**McLean District Design  
Guidelines  
Advisory Group Meeting #11**

**Community Feedback**

May 24, 2023

## Architectural Transitions

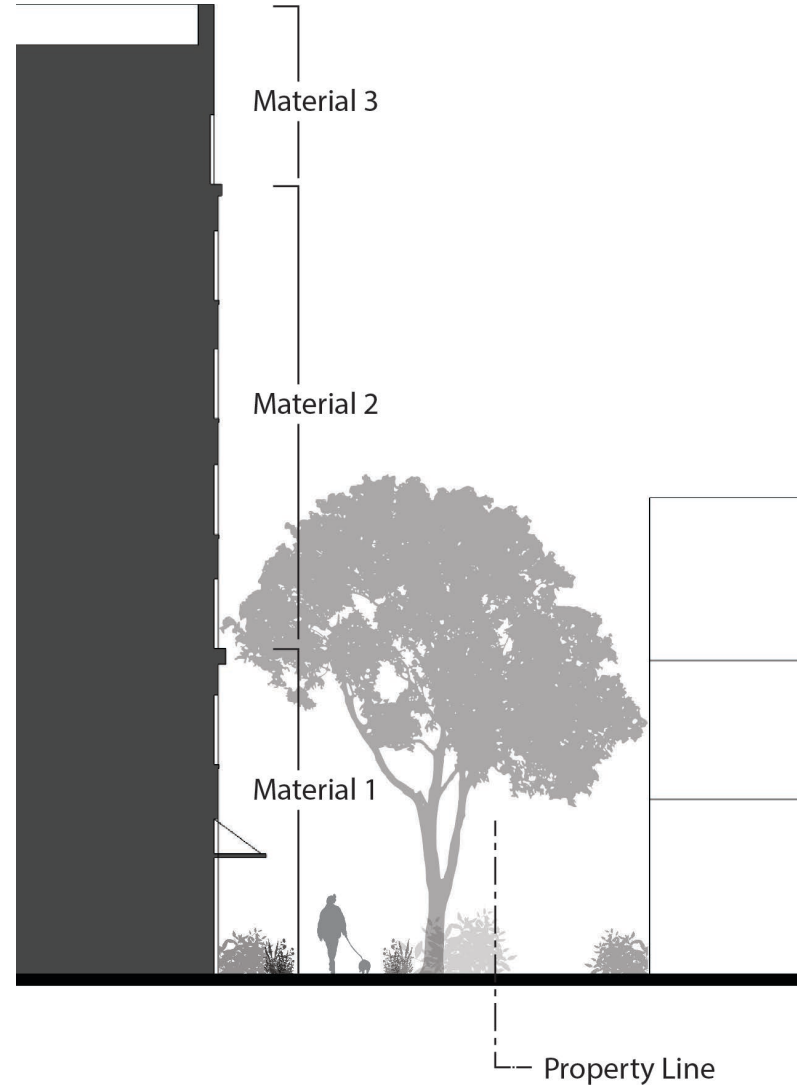
Comment: Guidelines disregard the hierarchy in the Comprehensive Plan to determine when architectural transitions should be used.

Proposed Solution: The Comprehensive Plan's development zones already establish a tiered transition in building heights. However, the plan also calls for architectural transitions in certain instances. The guidelines can help by showing strategies for incorporating architectural transitions consistent with the Plan.

## Green Avenues + Main Streets

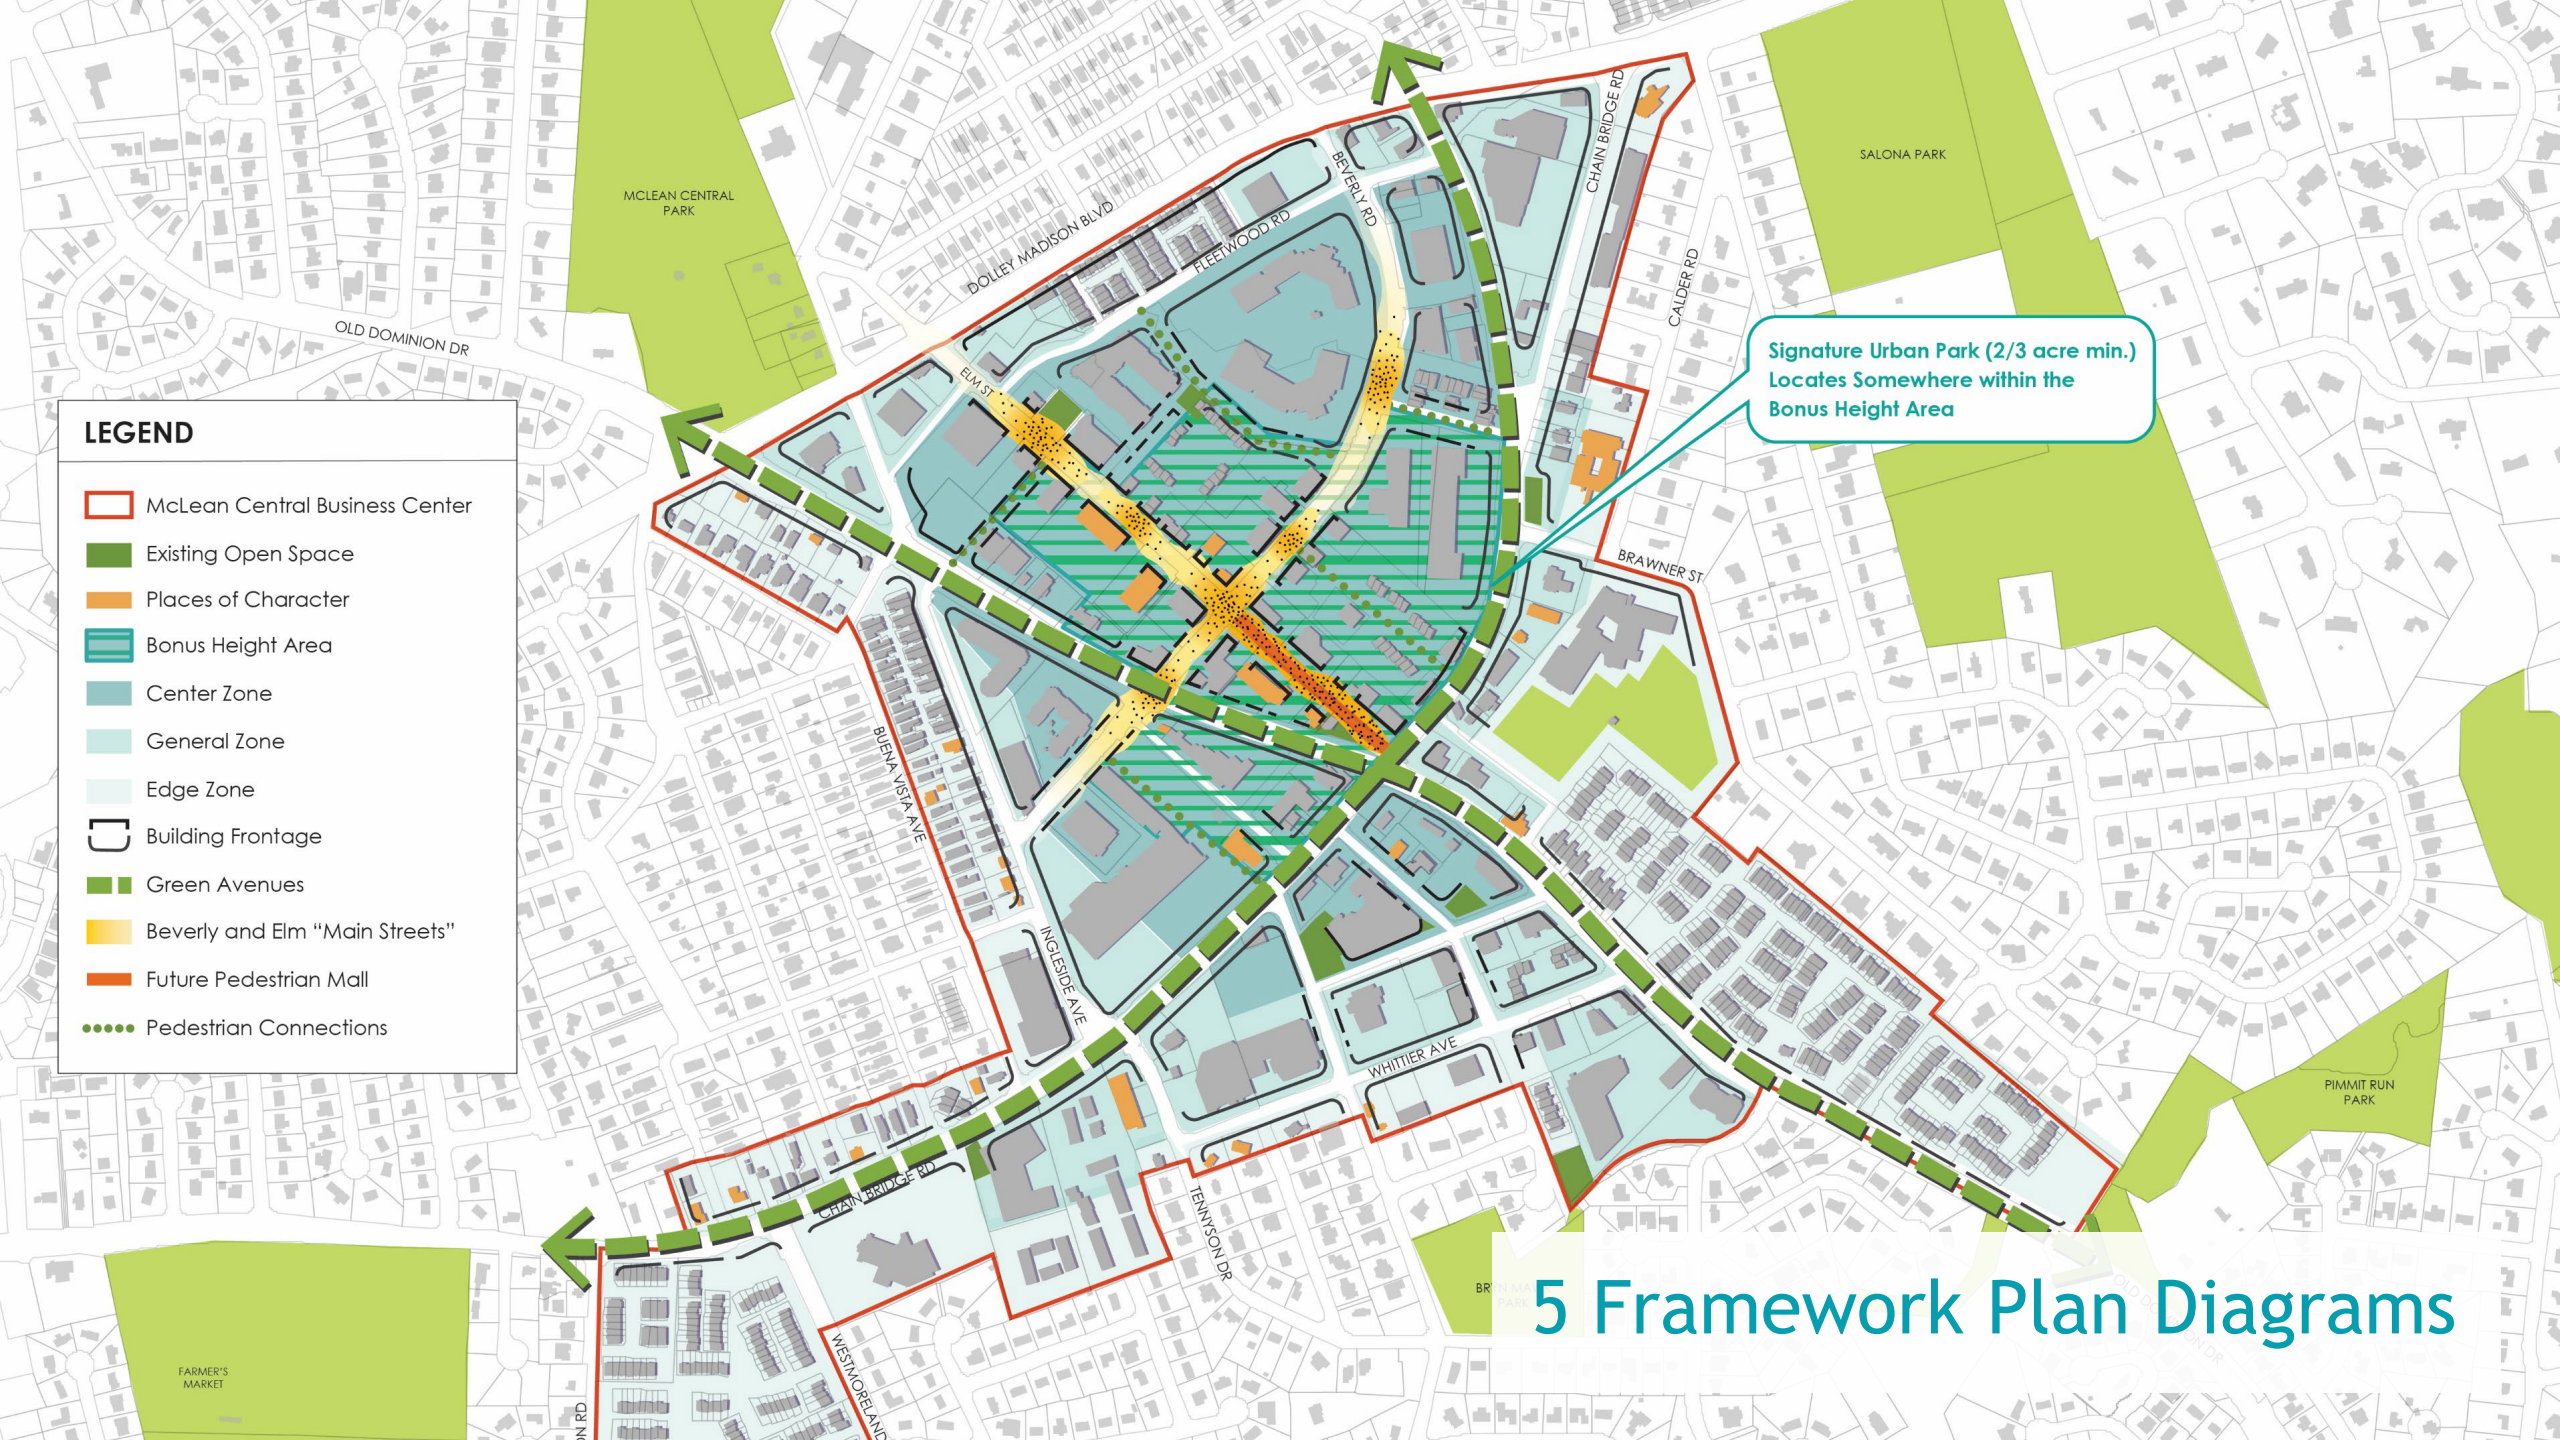
Comment: The terms "Green Avenues" and "Main Streets" are new taxonomies. Why is greening and buffering particularly important on the Avenues and why is "character" important along Beverly and Elm"?

1. Clarify: Comp Plan dimensions are not changing.
2. These new terms are a further elaboration of the Plan's intent. The plan has distinctive cross-sections for these 4 streets. It focuses on Beverly and Elm as the center of the redevelopment. It refers to using streets as green corridors.
3. The term "Main Street" is used to further elaborate on the type of character to be fostered.

## Framework Plan Diagrams

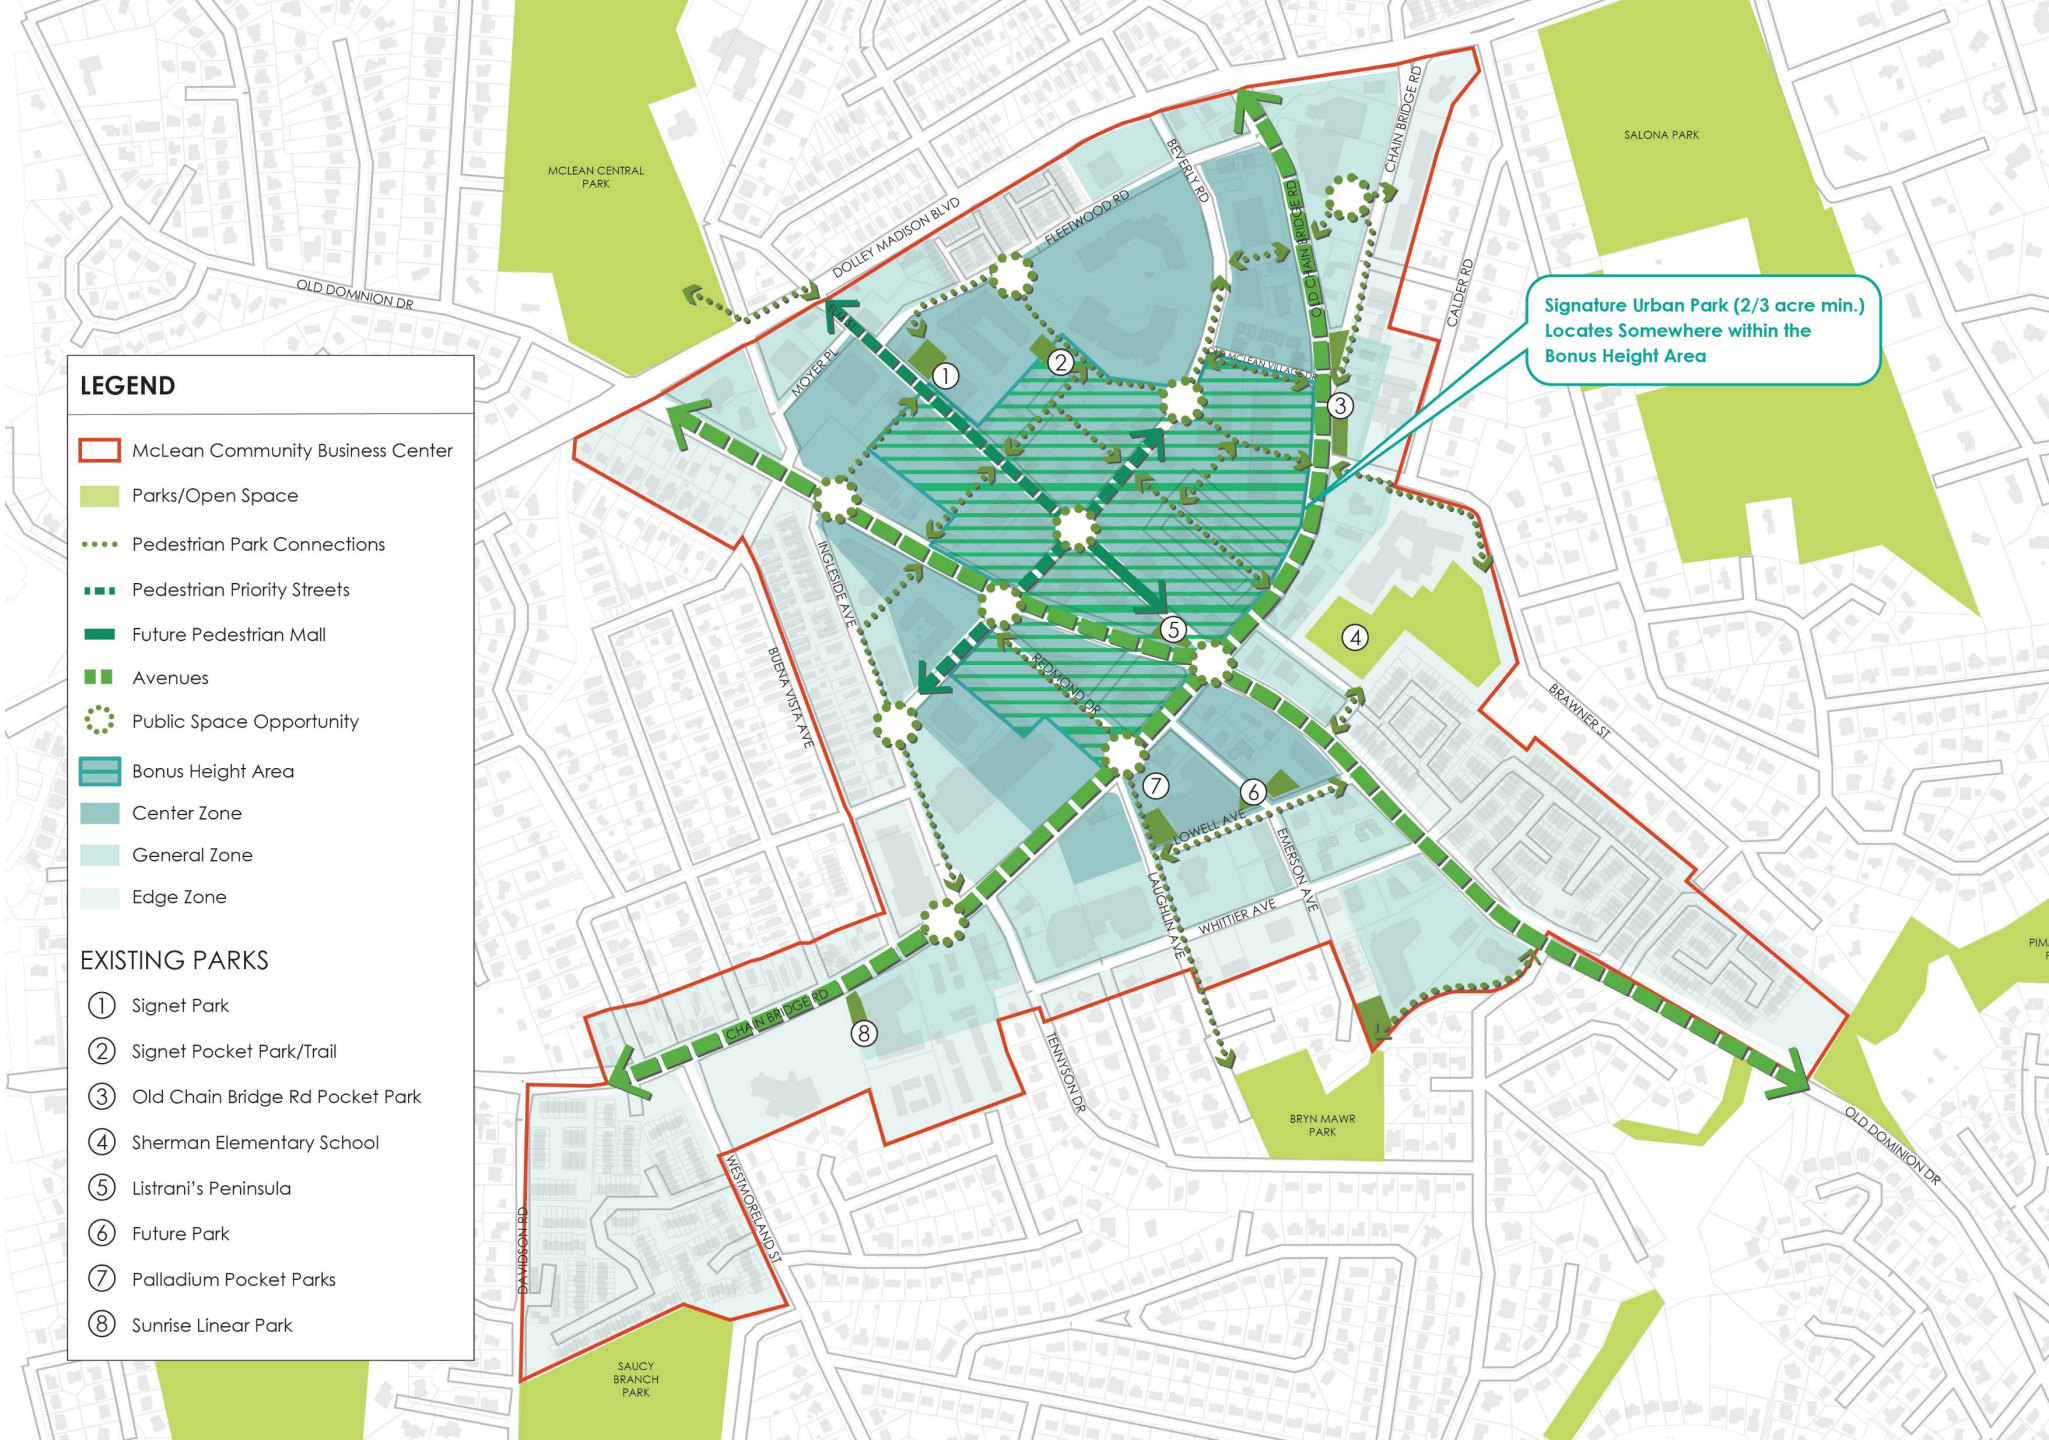
Scale of some of the case studies seems too large.

Updated graphics in framework plan. *(see next page)*

## Key Architectural Elements

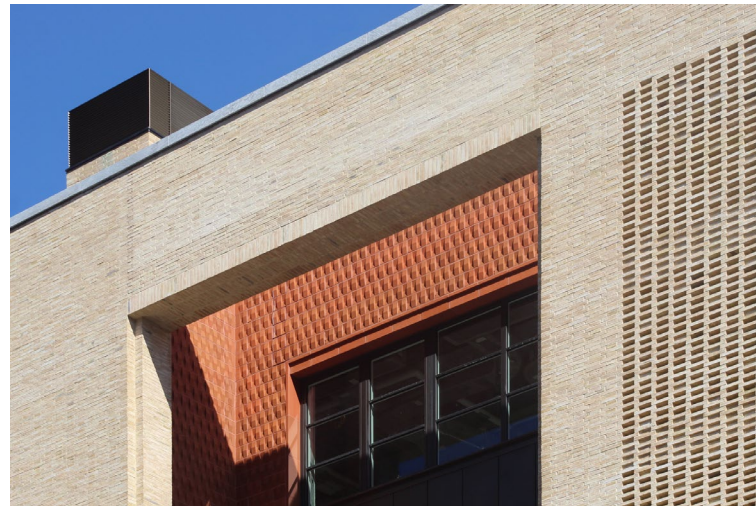
Comment: The term ‘vernacular’ in reference to McLean’s architectural style is unclear as there is no singular style in the CBC. Staff should either eliminate this term or further delve into architecture and architectural features common to McLean’s history that at build-out would give character to McLean.

1. Do not include style expectations in the Guidelines.
2. Focus on performance-based guidance articulating sound architectural principles that are desired in McLean:
  - Balanced Proportions
  - High-quality Materials
  - Well-articulated Details
